HASTINGS HERITAGE PRESERVATION COMMISSION

CERTIFICATE APPLICATION 7-2022

315 Pine Street. Pavel Zakharov – Third floor rehabilitation with addition

PROPOSED FRONT ELEVATION SCALE: 1/4" = 1'

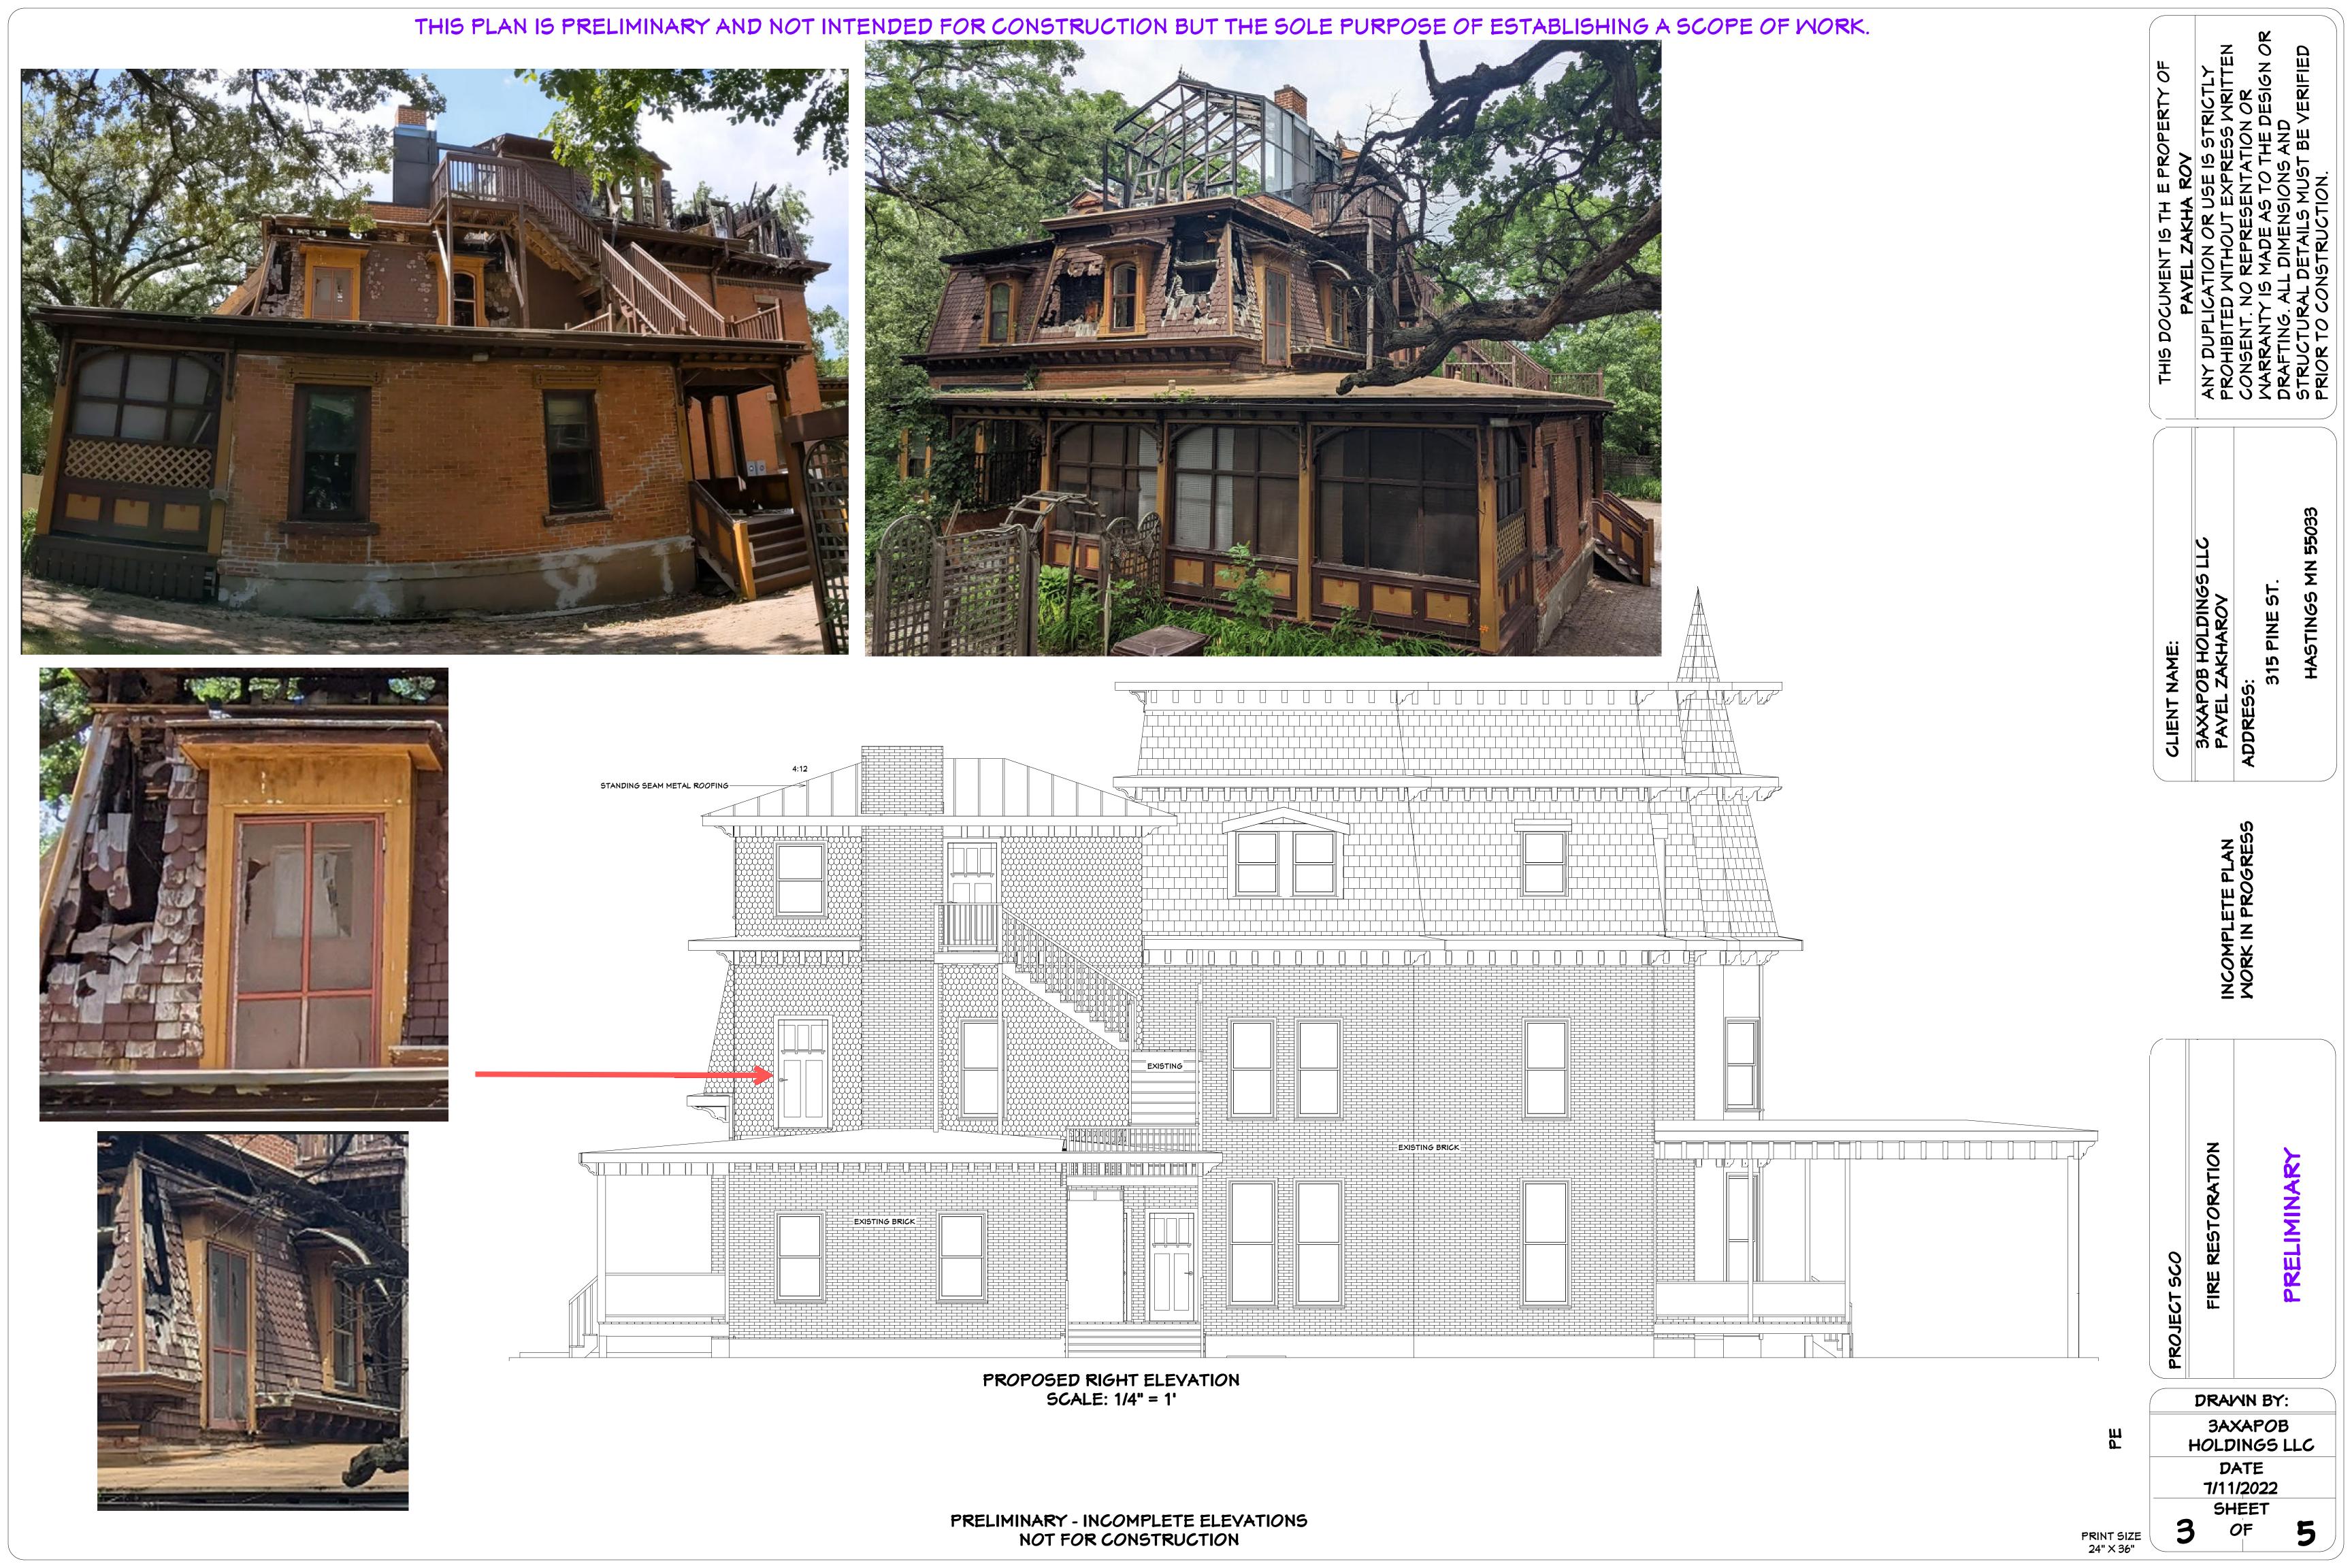
The windows in the existing mansard roofs have arched tops, but are shown on the elevation drawings are square, which may have been done for drawing expediency.

The plans show a couple new doors. One is on the east or right elevation. It's replacing an existing door. The walls in this location require reconstruction. This elevation seems to be showing the reconstructed walls to not be mansard. The second door is on the addition facing the left/ east elevation. There is insufficient detail to determine the type of door. These details can be reviewed at a future date.

The applicant states there are no plans to change the exterior of the mansard roof. There is an error in the drawing that shows the roof to be taller and include a 3rd cornice.

NOTE: THE INTENT OF THE RECONSTRUCTION IS TO MATCH AS MANY EXTERIOR DETAILS AS POSSIBLE. THIS PRELIMINARY PLAN IS INCOMPLETE IN DETAILS. THE FINAL PLAN WILL INCLUDE ALL DETAILING AS NEEDED.
